Kiowa Switch Fix

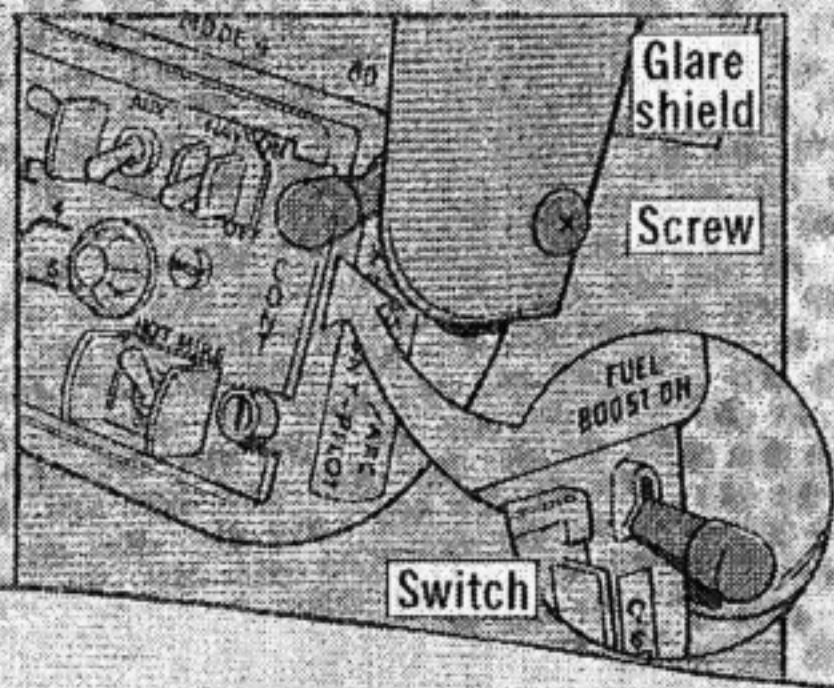
We have a problem with the fuel boost pump switch on an OH-58A with a crashworthy fuel system.

The switch housing rubs against the screw that holds the glare shield to the instrument panel.

Any ideas for a fix, Windy?

Sounds like the switch was installed a bit too far to the right.

Remove the screw and re-install it with the head on the inside of the glare shield and the nut on the outside. This will give the added clearance you need.
